# Service Bulletin

Bulletin No.: 16-NA-085

**Subject: New Design Cylinder Heads**

4509309

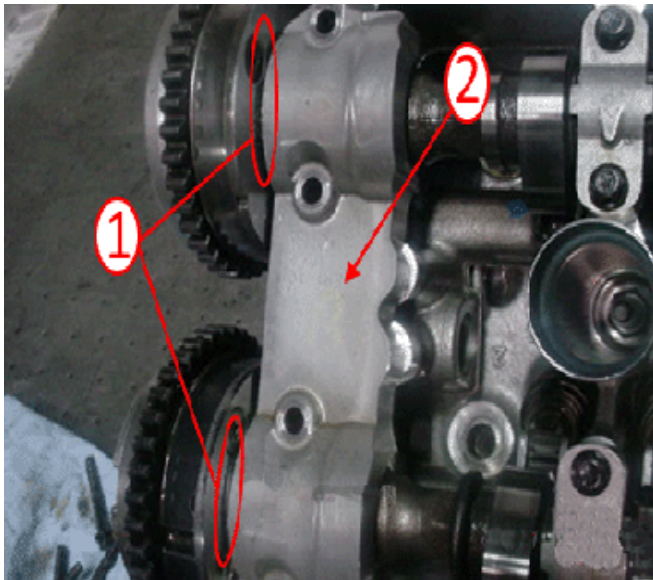
Previously Designed Cylinder Heads used a thrust washer (1) between the actuators and cylinder heads.

**Caution:** If you are using a 2011 new style "saddle cap" cylinder head, thrust washers are not to be used. The use of thrust washers on the new designed cylinder heads can cause damage to the cam shaft actuator, saddle cap and cylinder head.

4509294

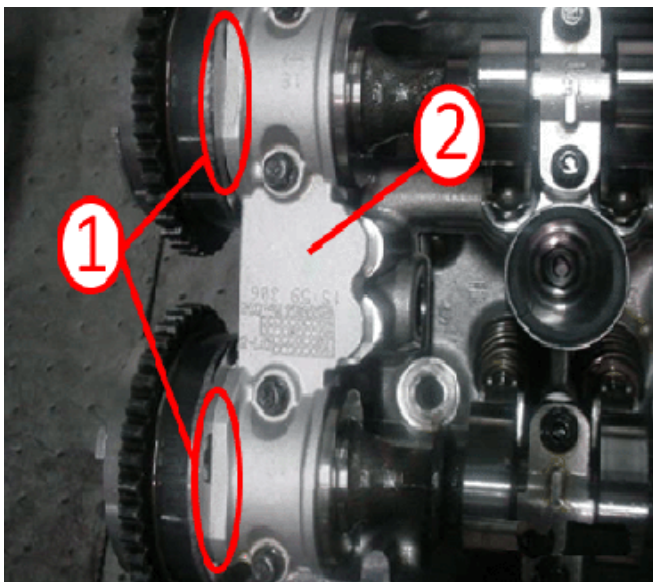
The new cylinder heads have a saddle cap (2), which incorporated a thrust surface on the saddle cap, has been designed to reduce the tolerance between the camshaft actuator and cylinder head, eliminating the need for a thrust washer.
